BAROSSA ASSESSMENT PANEL

AGENDA

6.1 24030311 - 98 Melrose Street Mount Pleasant

PROPOSAL	Construction of building additions to existing shop (butcher) including demolition of existing verandah, construction of new verandah (over footpath) and installation of one advertising sign
APPLICANT	Jimmythebutch Pty Ltd
OWNER	Jimmythebutch Pty Ltd
APPLICATION NO	24030311
CERTIFICATE(S) OF TITLE	CT 5710/480 (Lot 656) CT 5706/828 (Lot 3)
AREA	Lot 656 – 1881 square metres Lot 3 – 1934 square metres
CURRENT USE	Shop
PLANNING AND DEVELOPMENT CODE VERSION	Version 2024.17 – 12 September 2024
PLANNING AND DESIGN CODE EXTRACT LINK	Relevant Code Extract
ZONE	Township Main Street Zone Township Neighbourhood
OVERLAYS	Character Preservation District Historic Area Hazards (Bushfire - medium risk) Hazards (Flooding - evidence required) Local Heritage Place Mount Lofty Ranges water supply catchment (area 2) Native Vegetation Prescribed Water Resources Area Traffic Generating Development Urban Transport Routes Water Resources

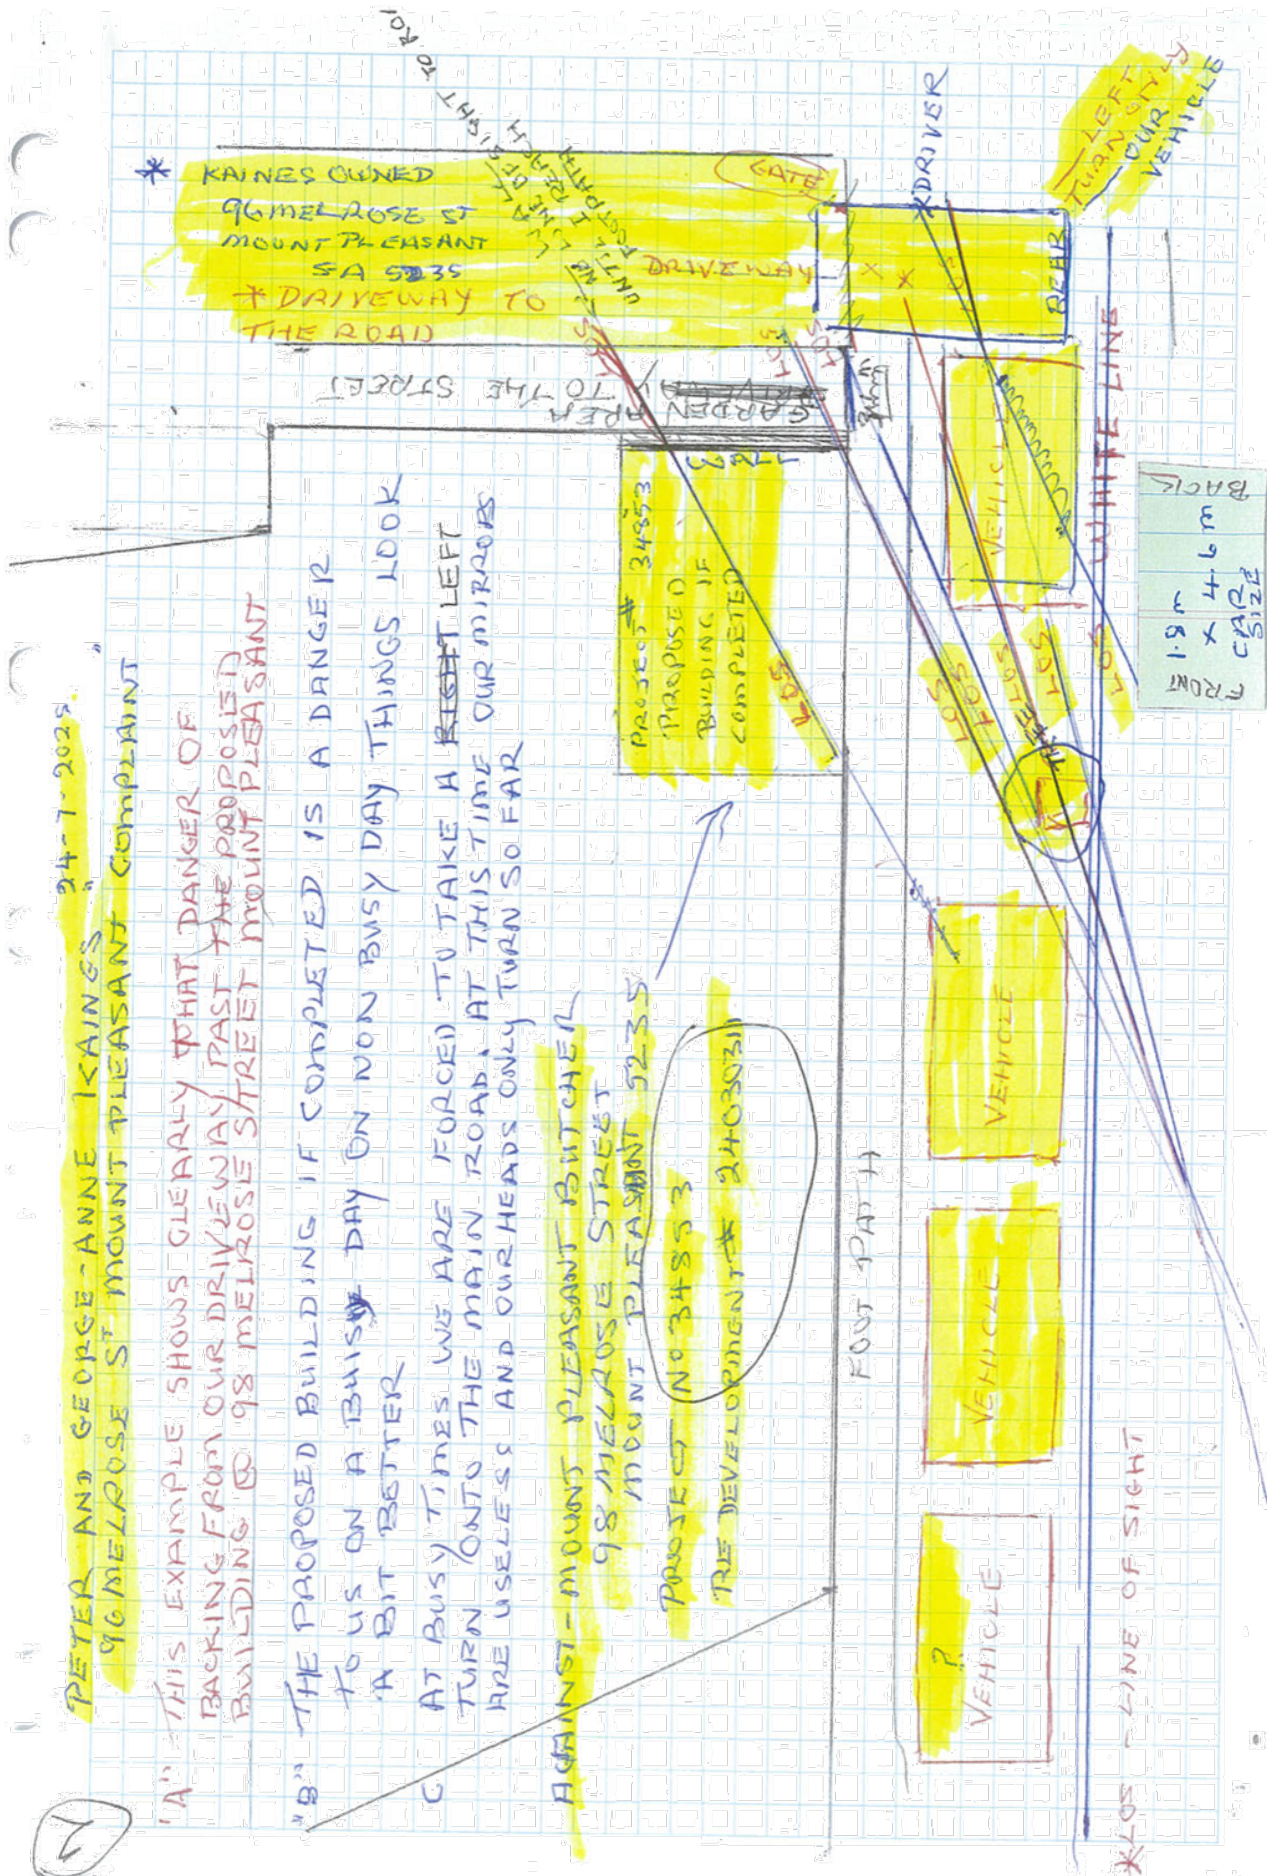
Proposed extension coming out to kerb level will completely block our line of sight to the right when exiting our property.

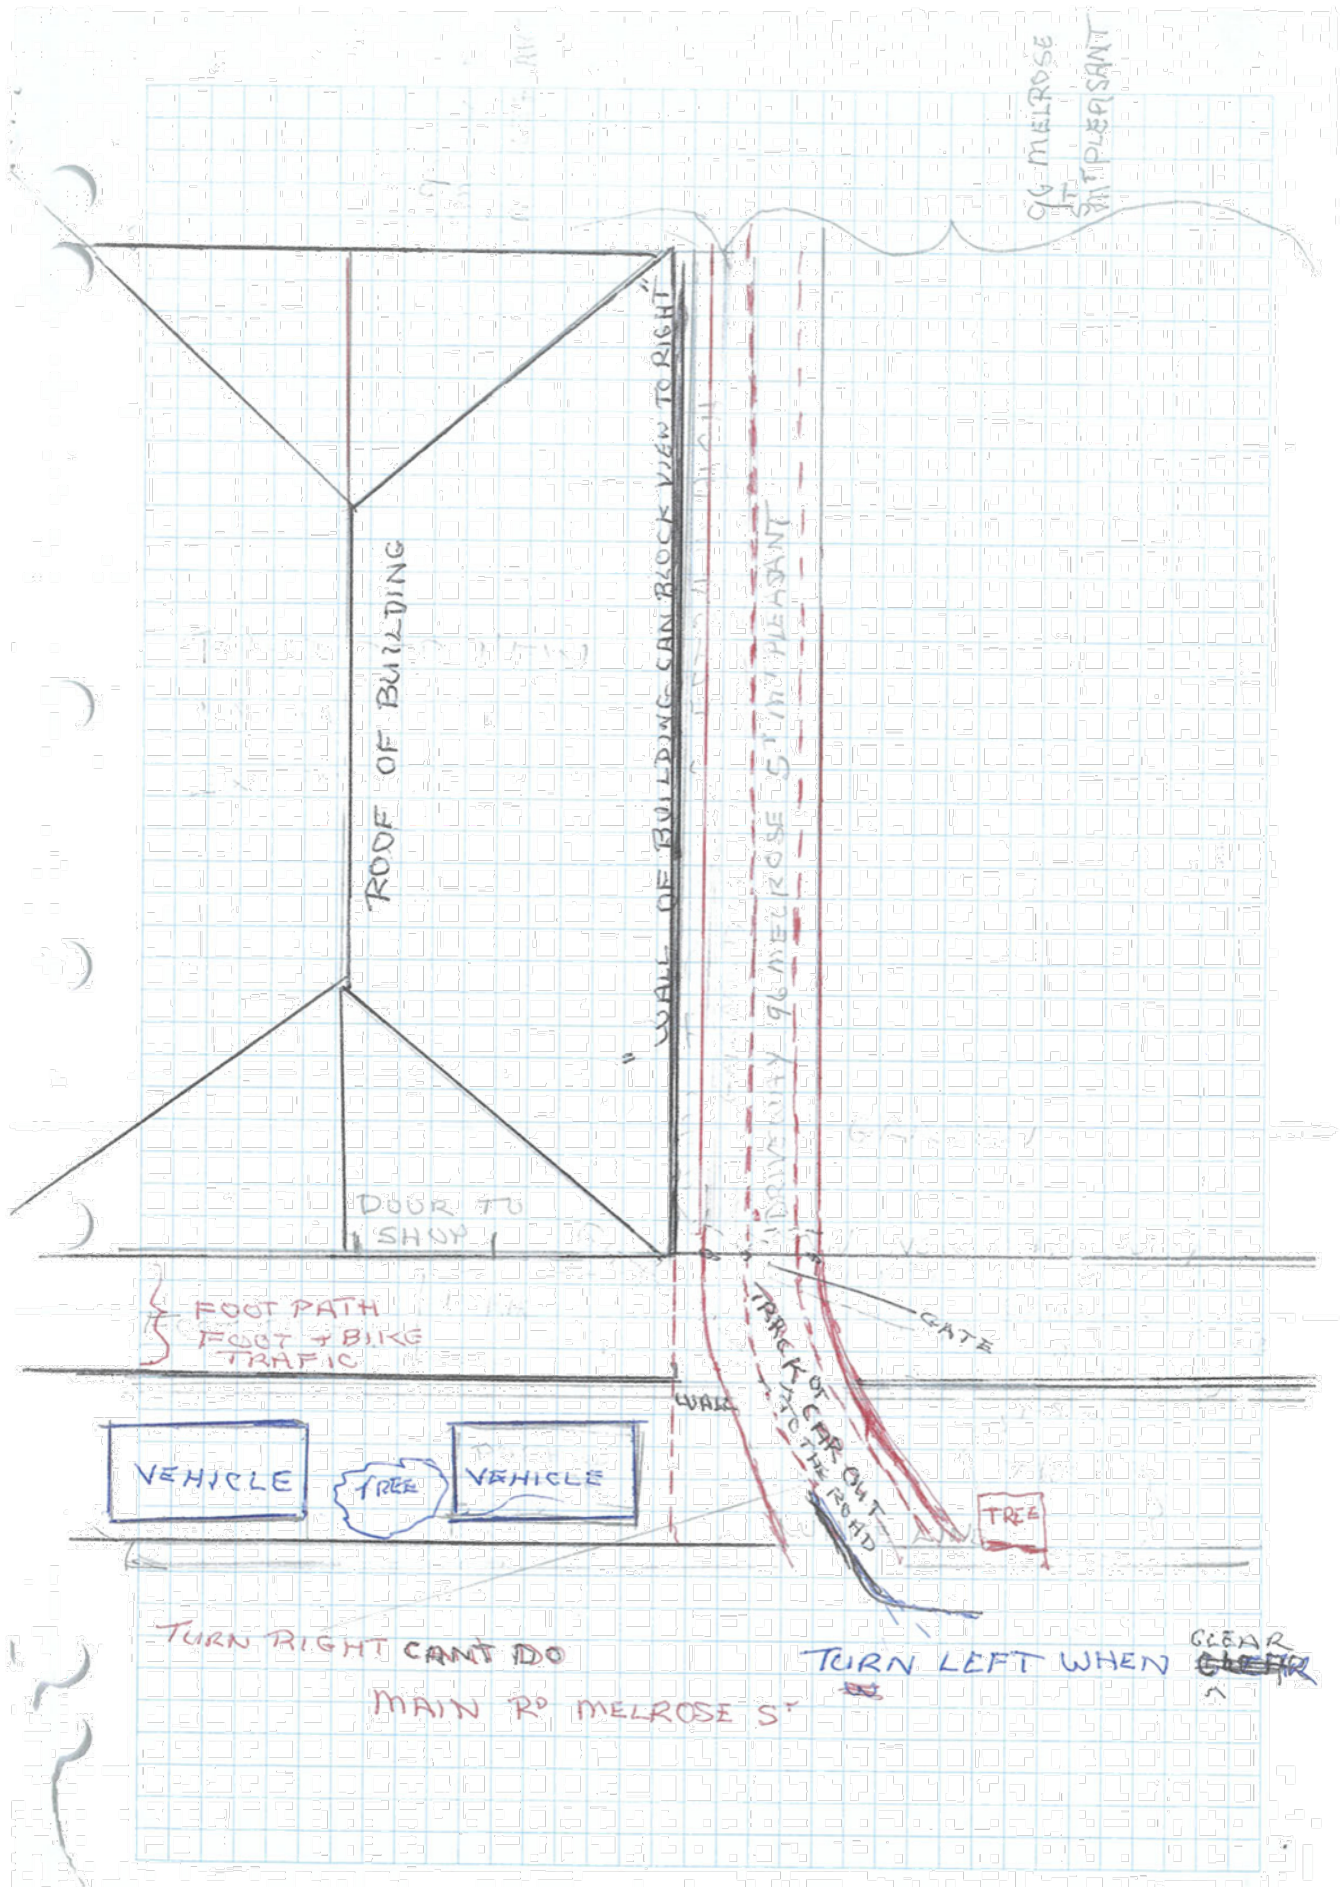
Position of street trees limits road parking for customers to the shop and limits our line of sight in any case.
